**JOINT REGIONAL PLANNING PANEL
(Sydney East Region)**

JRPP No	2011SYE116
DA Number	DA.47/11/2
Local Government Area	North Sydney
Proposed Development	To modify consent for demolition of existing structures, amalgamation of the three allotments and construction of a 22 storey mixed use building above basement car parking comprising commercial tenancies including a restaurant, 193 units, landscaping, a through-site-link and roof level communal facilities including a gym and swimming pool.
Street Address	136-142 Walker Street North Sydney
Applicant/Owner	Winten Developments Pty Ltd
Number of Submissions	One
Recommendation	Approval with Conditions
Report by	Geoff Mossemeneer, Executive Planner, North Sydney Council

Assessment Report and Recommendation

136-142 Walker Street view analysis • Unit 1104 south - existing RL 110.0
Spence Pearson Architects P/L 20.04.11

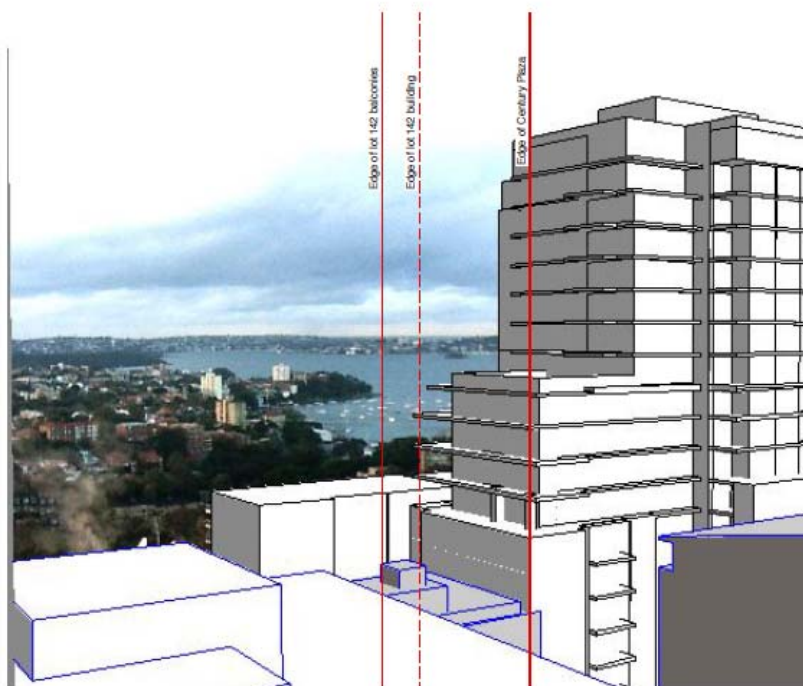
- Object to modification M - which is the positioning of the plant room on the roof of the northern portion (142 block) of the development. This once again raises the height of the development on the 142 Walker Street block past the RL limit for

that block. This further impinges on the views and amenity of premises in 37-39 McLaren street as well as probably the Harvard apartments on the corner of McLaren and Miller street. Please see council report of 16/05/2011 that kindly did a sight line analysis for the building from apartment 1104 at 37/39 McLaren street. Could it be possible to keep the plant room (M) alteration as close to the main tower (south end) of the development on the 142 roof to ensure it doesn't further impinge on views/amenity.

The submission raises concern about the addition of plant on the lower tower and possible view loss. The applicant states that the plant room is required for stair pressurisation of Core B. The plant is required to be located above the stairs and core and would be difficult to move.

The assessment of the application had regard to the impact on views from apartments to the north west of the site. The following photos show the views from the submittor's balcony:

Having regard to the above plan and elevation and the view photos, the majority of the plant would not cause any further impact. The eastern edge of the plant is likely to block a small amount of the water (not the water/land interface). The impact is considered to be negligible and therefore acceptable.
